**Key objections to the ‘soundness’ of
AMENDMENTS to
SLDC’s *Land Allocation Development Plan
Document (LADPD)*
for Grange-over-Sands and district**

May 2013

Submission Overview

This statement has been prepared on behalf of Grange-over-Sands & District Action Group (GADAG), representing more than 200 members and supporters who are residents of Grange-over-Sands and of the Cartmel Peninsula, Cumbria.

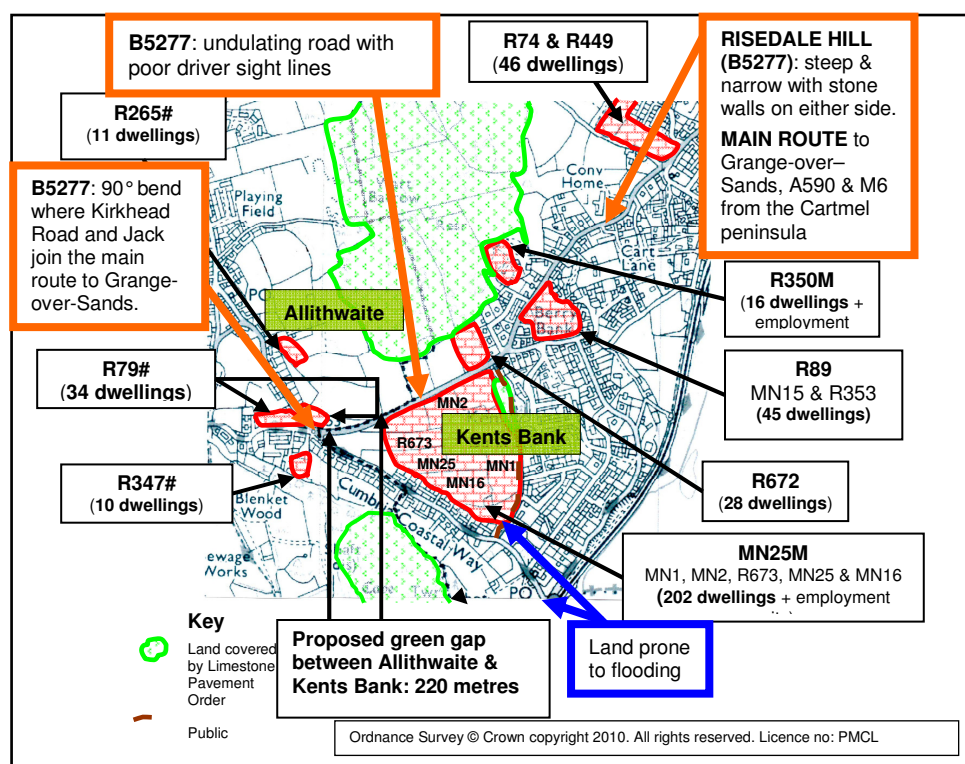
- The **B5277** is **the only through road** connecting to South Lakeland's other Service Centres and the M6. It has a serious traffic bottle neck on Main Street in the middle of *Grange-over-Sands Conservation Area 1*. When this is blocked by delivery vehicles traffic cannot move in either direction.
- **Local topography** and the **underlying limestone geology** mean that the original Victorian waste water system is already at 'breaking point and is not robust enough to cope with additional run-off water from 500 additional residential units and an unspecified number of employment units.
- **Key Service Centre**: Grange-over-Sands does not meet SLDC's definition of a Key Service Centre.
- **Tourist economy**: Grange-over-Sands' tourist economy will be adversely affected by SLDC's inappropriate development proposals for the town.

Even though **Grange-over-Sands Town Council** and **local residents** have alerted SLDC to these problems throughout SLDC's *Public Consultation* exercises in **2010, 2011** and **2012** and at the **Public Hearing** in October 2012 **SLDC has NOT AMENDED their LADPD** to address any of these **SUSTAINABILITY PROBLEMS** for Grange-over-Sands.

Instead, they have concentrated their efforts on liaising with local land owners, their agents and developers.

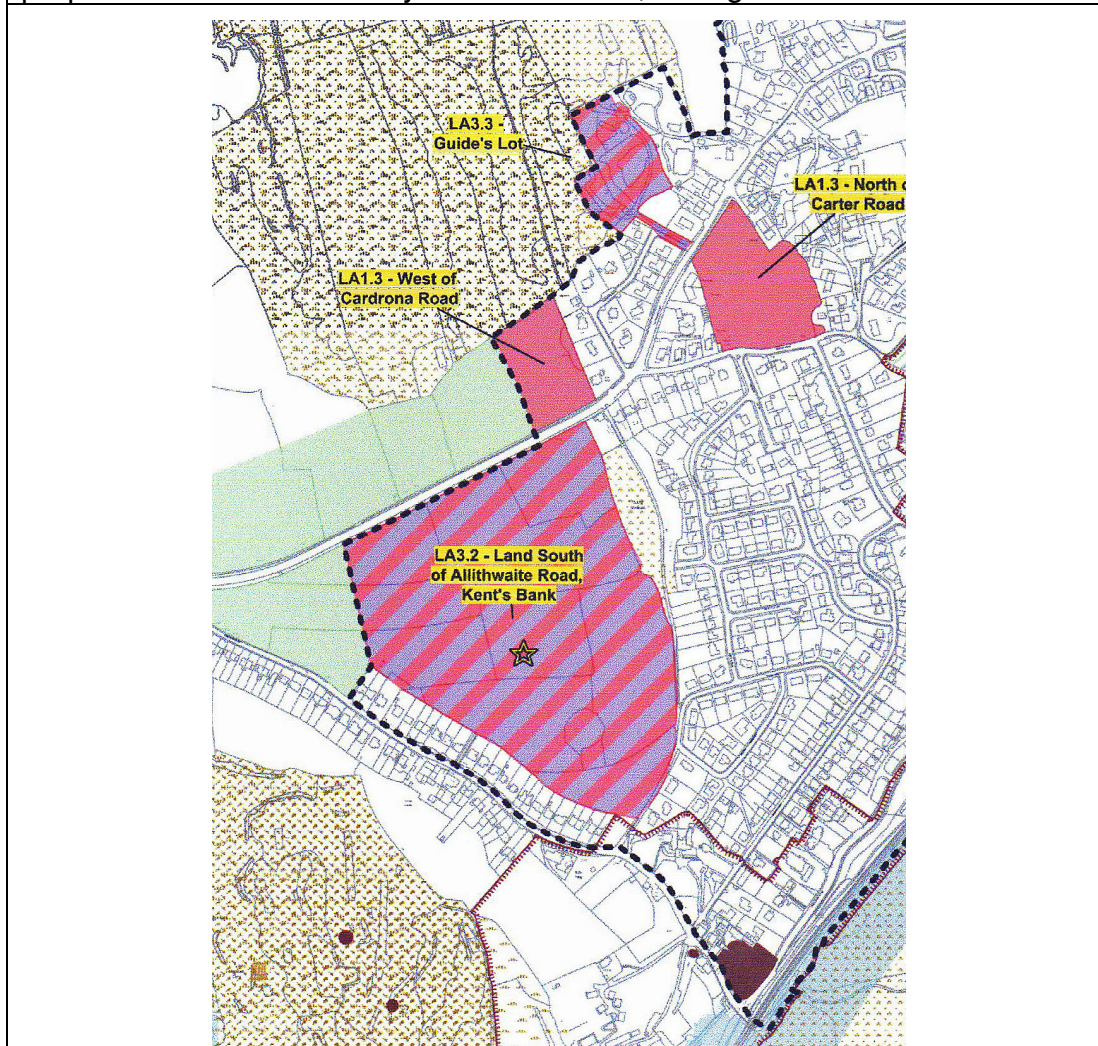
- **SLDC's green gap assessment:** is incompetent, contains factual inaccuracies, does not define the extent of the current green gap or the proposed green gap and suggests that a 220 metre gap on the B5277 through road (Allithwaite Road) is sufficient to protect against coalescence.
- **Southern side of the B5277:** The Impact of development proposal *LA1.3 Land south of Allithwaite Road* HAS NOT BEEN INCLUDED in SLDC's GREEN GAP ASSESSMENT even though it will cover 11.2 hectares of green fields that separate Kents Bank, Grange-over-Sands from Allithwaite.
- **Proposed green gap:** a 220 metre gap on the B5277 through road (Allithwaite Road) is sufficient to protect against coalescence.

Even though **Grange-over-Sands Town Council** and **local residents** have alerted SLDC to this problem throughout SLDC's *Public Consultation* exercises in **2010**, **2011** and **2012** and at the **Public Hearing in October 2012** **SLDC** has **NOT AMENDED** their **LADPD** to address the **SIGNIFICANT IMPACT** that their **PROPOSED GREEN GAP** will create for the **INTEGRITY** of **KENTS BANK** and **ALLITHWAITE** as **SEPARATE COMMUNITIES**.

Map 3 Section from SLDC's Map EX063 Grange South showing SLDC's proposed eastern boundary for Allithwaite

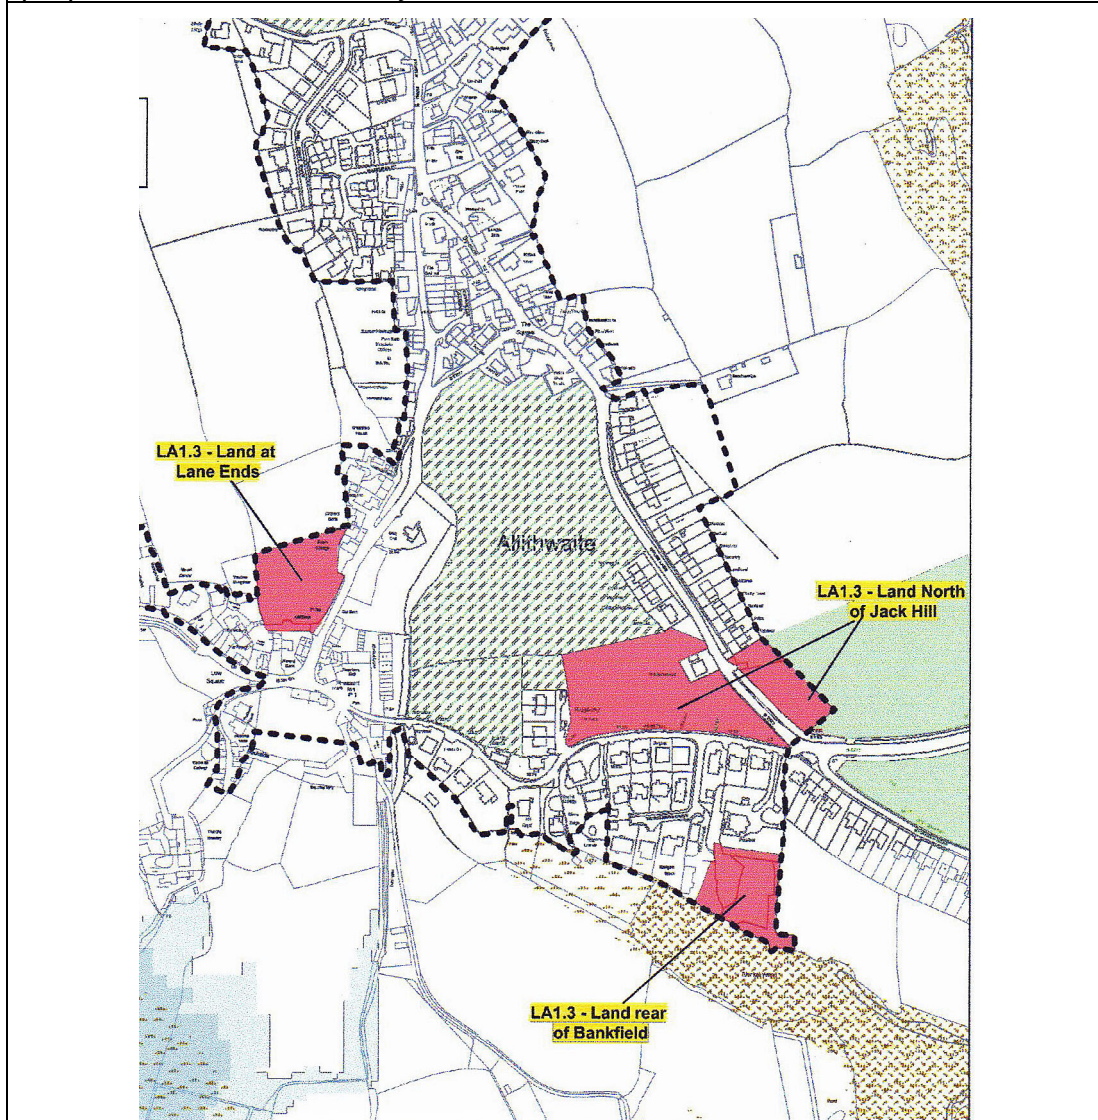
1. The lower end of Kirkhead Road is shown as the south western boundary but houses on the west side of the road are not included.
2. The parish boundary on Ordnance Survey maps shows that the boundary continues across Kirkhead to Kirkhead End and does not run down Kirkhead Road as shown (see Map 1). The houses on both sides of Kirkhead Road, below Laneside Farm, are shown on Ordnance Survey maps as part of Kents Bank.
3. The Allithwaite boundary at the 90° bend between Jack Hill and Kirkhead Road is just off the map but is shown on the Allithwaite map. It is 220 metres from the western edge of site LA3.2 Land South of Allithwaite Road (MN25M).

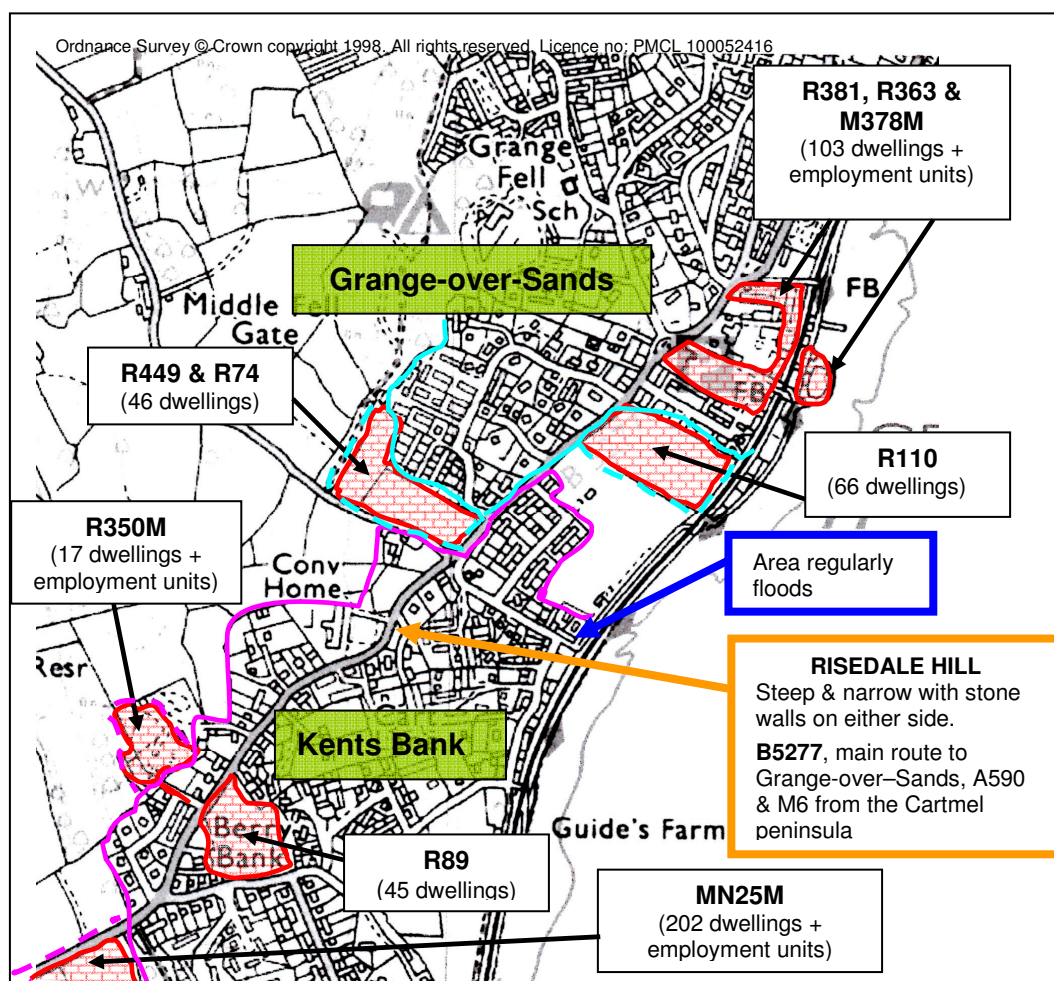
- **Proposed development in Conservation Area 3:** will destroy one of the remaining green field sites that are an integral part of the Victorian heritage of the town. This area of was left open so that visitors to the town could enjoy the ever-changing views of Morecambe Bay.
- **Proposed development opposite Conservation Area 3:** will destroy a green field site that is an integral part of mosaic of green field pastures that typify the vernacular architecture and setting of Grange-over-Sands.

Even though **Grange-over-Sands Town Council** and **local residents** have alerted SLDC to this problem throughout SLDC's *Public Consultation* exercises in **2011** and **2012** and at the Public Hearing in October 2012 **SLDC HAS NOT AMENDED** their **LADPD** to address the **SIGNIFICANT IMPACT** that their **PROPOSED INFILLING DEVELOPMENT ALLOCATIONS** will have **Grange-over-Sands'** unique identity as a Victorian coastal resort.
